MIAMI BEACH

PLANNING DEPARTMENT
Staff Report & Recommendation

Design Review Board

SUBJECT: DRB21-0739
291 Palm Avenue

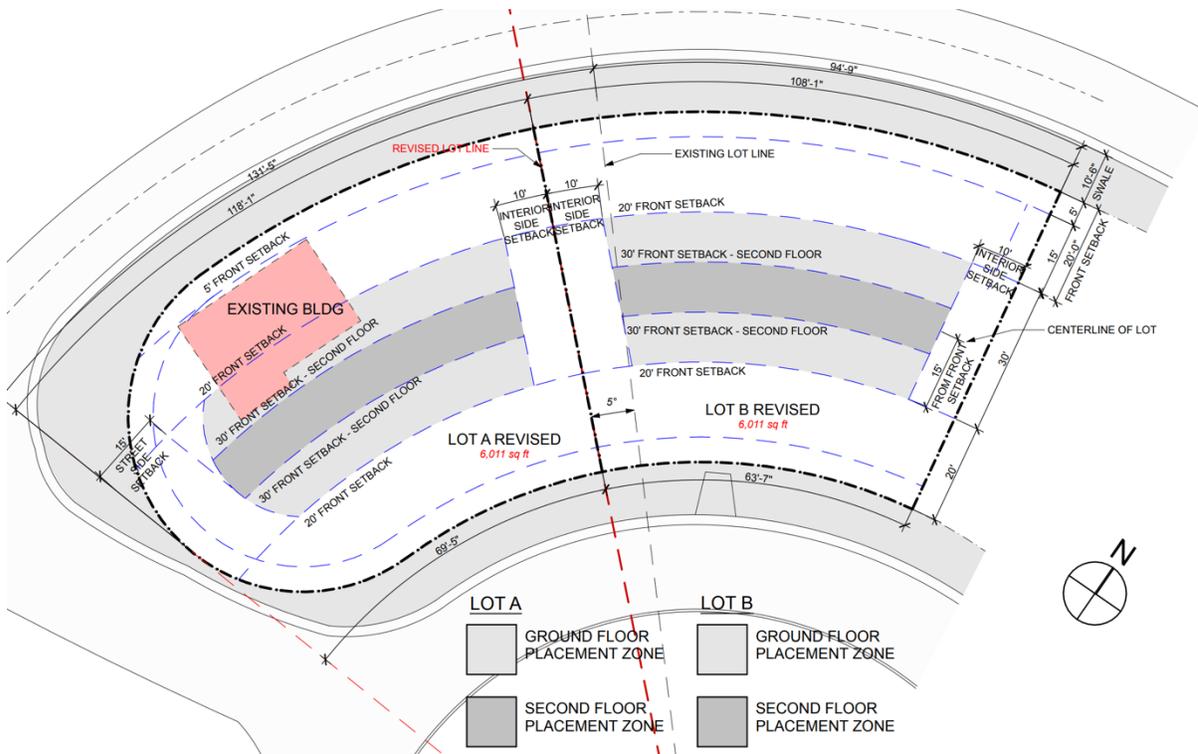
Due to the complexity and number of variances requested, staff has included below some of the variance diagrams provided with the application. The diagram below, from Sheet A-019 of the application, outlines the general setback requirements for the two single family lots resulting from the lot split application approved by the Planning Board on October 26, 2021. 'Lot B Revised' is the subject lot that is part of this application.

This lot is rather unique in that it has a curved trapezoidal shape, with two street fronts and is also very shallow, with a lot depth of only 70 feet. Most single family lots on Miami Beach have a lot depth of at least 100 feet. The diagram below shows that absent any relief from the City code, with the current required setbacks, the maximum width of a single-story home is 30 feet, and the maximum width for a 2-story home is only 10 feet. This shallow lot depth, as well as the unique bean shape of the lot, does present a hardship for the construction of any home on the subject site.

Although supportive of the majority of the variances requested, as noted below, due to the unique shape and depth of the lot, staff does believe that the applicant is attempting to place too much mass on the site, which is further exacerbated by the number of variances requested. For this reason, staff is recommending a slight reduction in the maximum unit size (from the requested 50% down to 45% - **Variance #2**) and from the requested lot coverage (from the requested 31.2% down to 30% - **Variance #1**).

The diagram below, from Sheet A-019 of the application, highlights the proposed building foot prints for each lot, and the area highlighted in salmon color indicates the portion of the home that encroaches into the a 20 foot front yard. However, it also must be noted

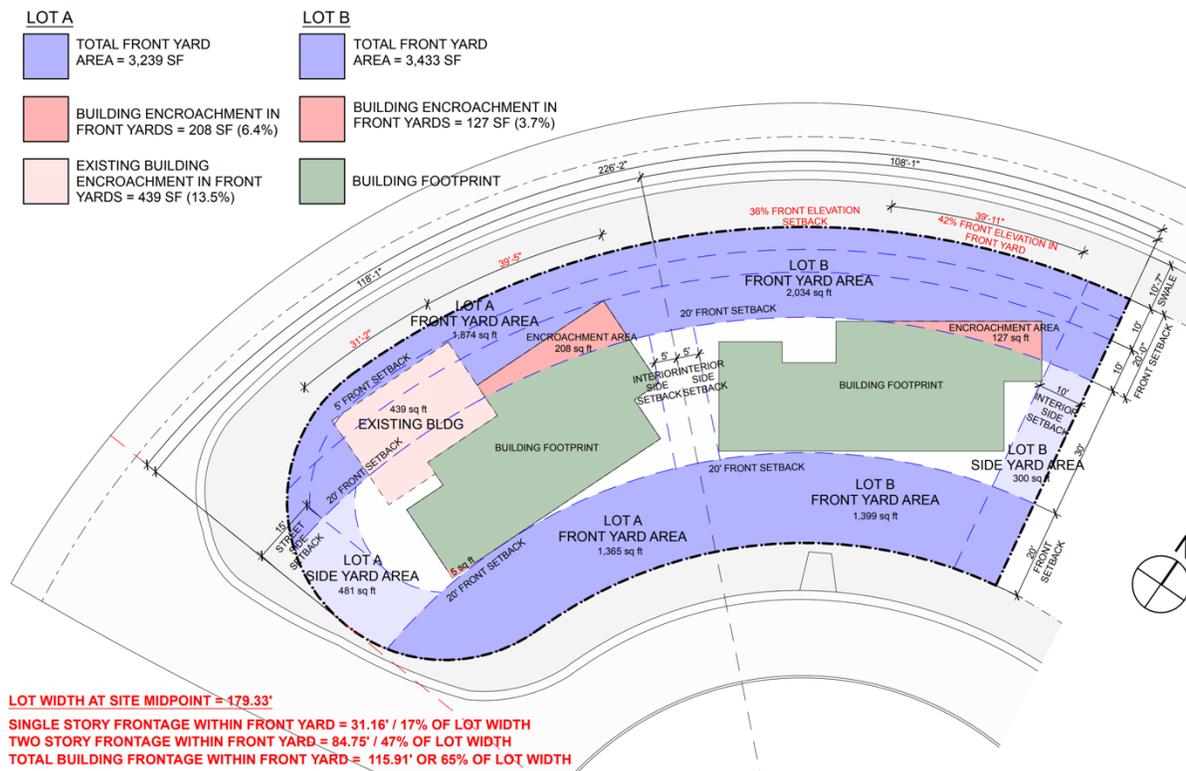
that the required setback is actually 30 feet, as the structure is 2-stories, but the purpose of this diagram is to show that only portions of the home encroach into a 20 foot front yard along North Coconut Lane. Staff would also point out that the existing 2-story home (although much lower in height than the proposed new home) has a setback of around 5 feet for a large frontage of the home along North Coconut Lane. Again, based upon the hardship presented by the unique shape and depth of the lot, staff is supportive of the requested variances related to the primary setbacks of the home (**Variances #3 & #4**), including the proposed interior side setback and sum of the side yard setbacks (**Variances #5 & #6**).

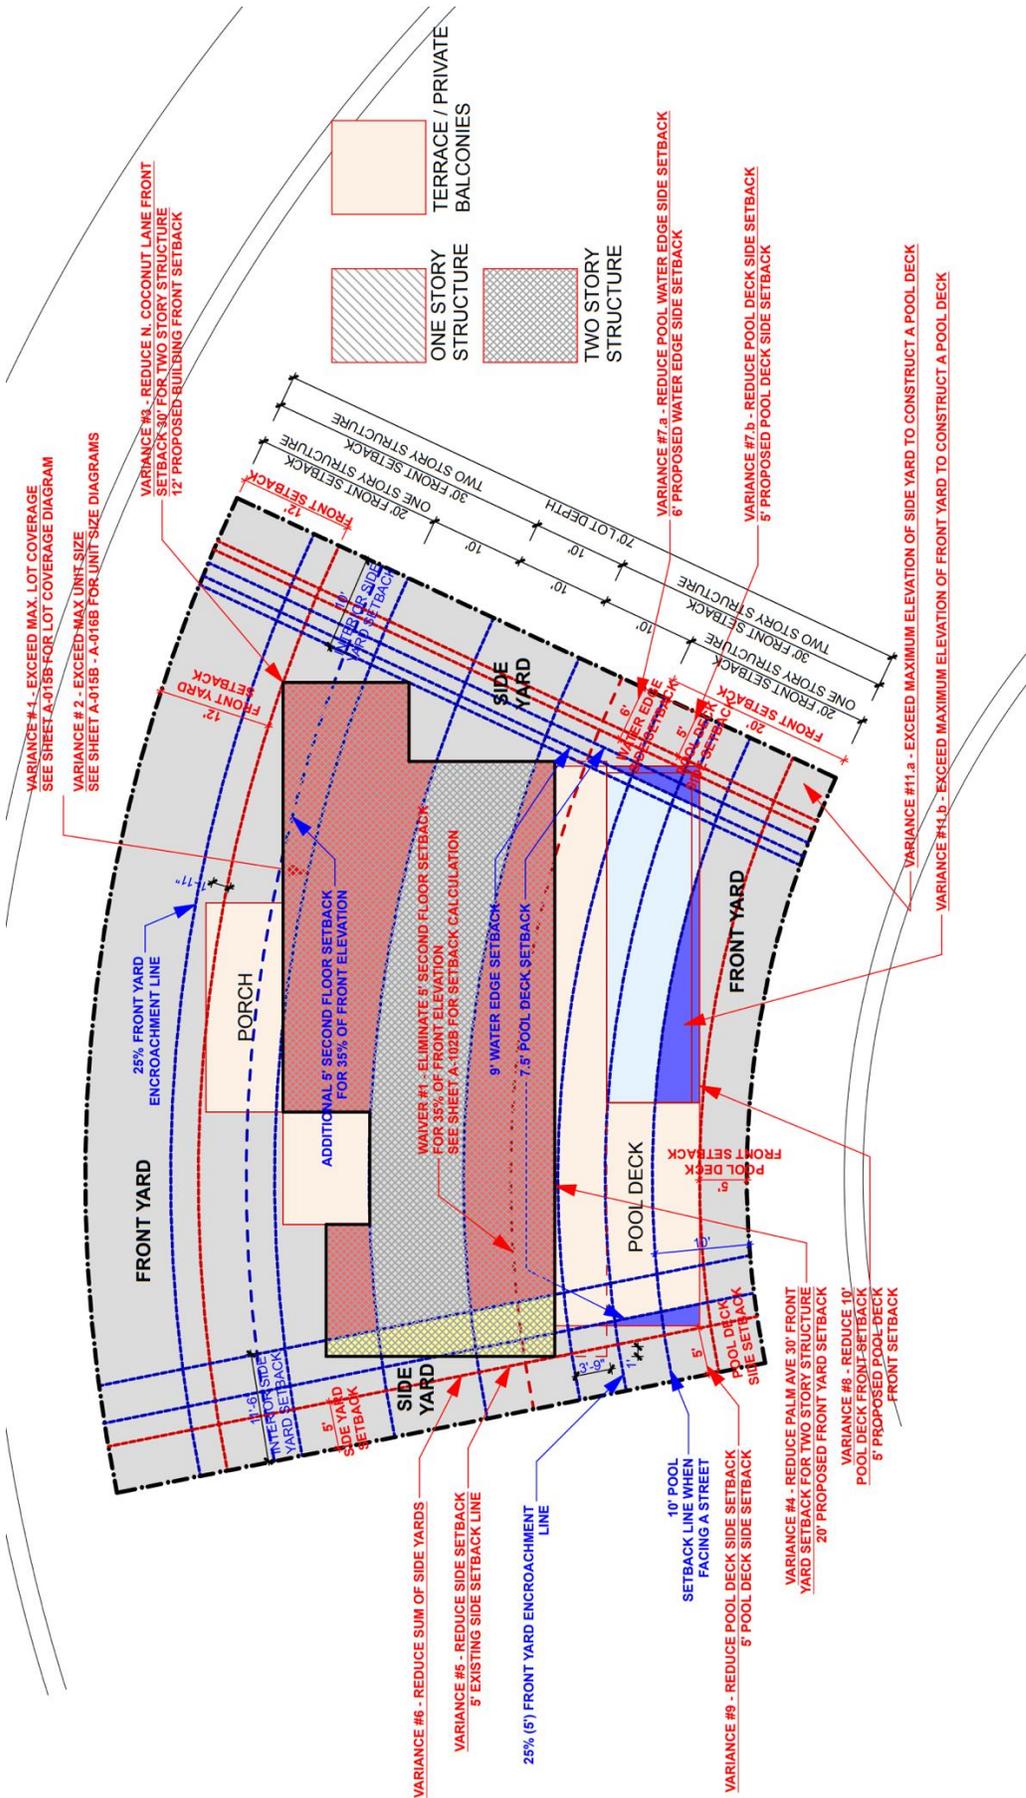
9. A Variance from Sec. 142-106(b)(16)b.1 to allow a pool's deck in side yard setback to be 5'-0" where 7'-6" is required.

Variations #7, #8, and #9 relate to the setback requirements for the pool and pool deck. Due to the irregular shape of the lot, minimal lot depth, and because the lot has two frontages, staff is supportive of the variations for the western side of the lot, which abut the companion lot that was part of the lot split process. As the eastern side abuts an existing property, staff recommends that the pool and pool deck on the eastern side of the site comply with the setback requirements so that the abutting neighbor is not negatively impacted by the proximity of the pool deck.

Modification recommended (Eastern deck shall comply with the minimum required setback)
